Title: MODIFICATION OF API 581 CARBONATE CRACKING – Confirmation Ballot

Purpose: Modification of the damage factor to include susceptibility chart

AMERICAN PETROLEUM INSTITUTE
 API RP 581 – RISK BASED INSPECTION METHODOLOGY
BALLOT COVER PAGE

Figure 10.1 – Determination of the ACSCC DF

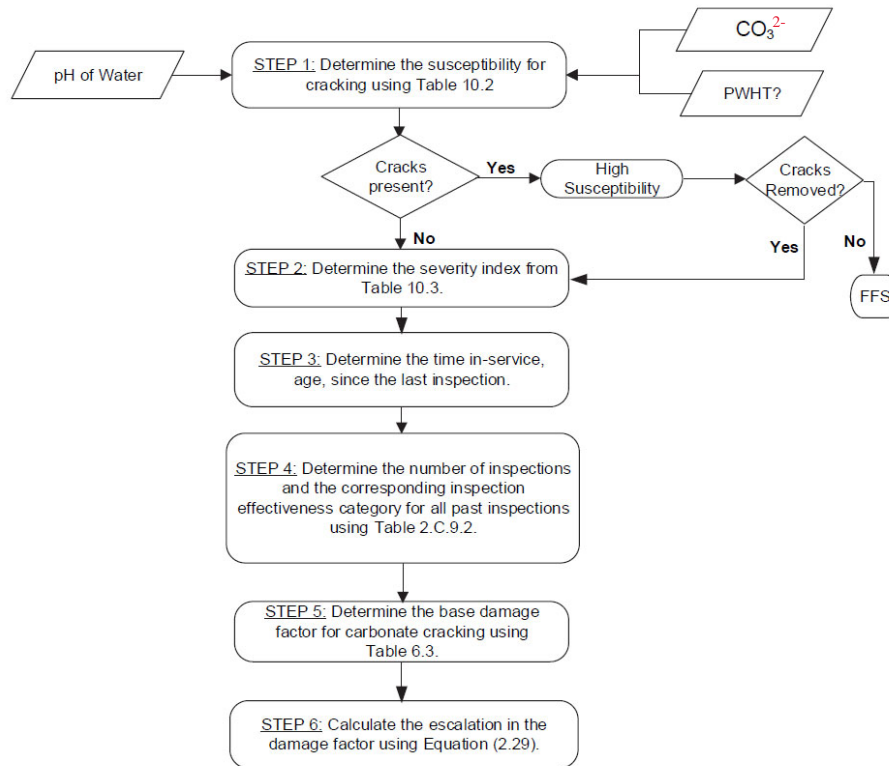
Rationale: To update Part 10 based on the modified susceptibility range. This was derived from NACE chart for pH versus Carbonate ion.

a) STEP 1 – Determine the susceptibility for cracking using [Figure 10.1](#) and [Table 10.2](#) based on the pH of the water, CO_3^{2-} concentration, and knowledge of whether the component has been **PWHT/dstress relieved**. Note that a HIGH susceptibility should be used if cracking is confirmed to be present.
